Our Case Number: ABP-311315-21

Re: Park development project at the Racecourse Park
Located between Baldoyle and Portmarnock, Co. Dublin

Re: Racecourse Park Baldoyle JP06F.311315

“TM 25

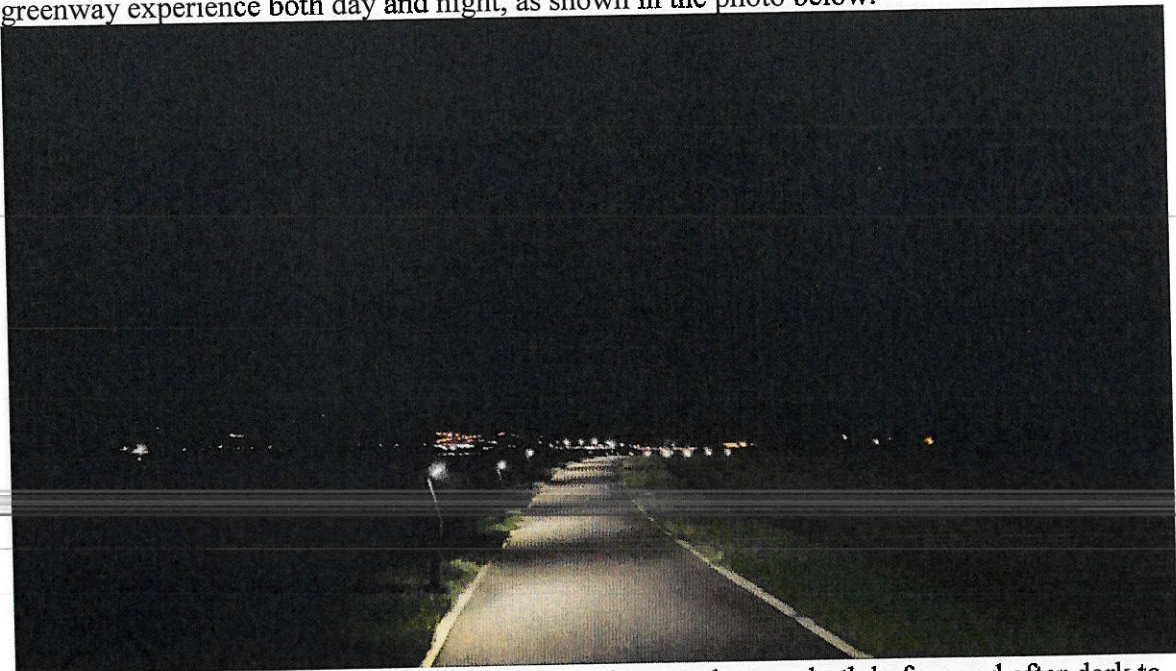
The proposed approach here is in direct contrast to that being taken in the adjoining Local Area Plan, where the explicit intention is to avoid overprovision of car parking:

“As development progresses, require that car parking standards within the LAP lands are reviewed in parallel with improvements in public transport services with the aim of implementing reduced levels of car parking which would reflect the strategic nature of the LAP adjacent to public transport.”
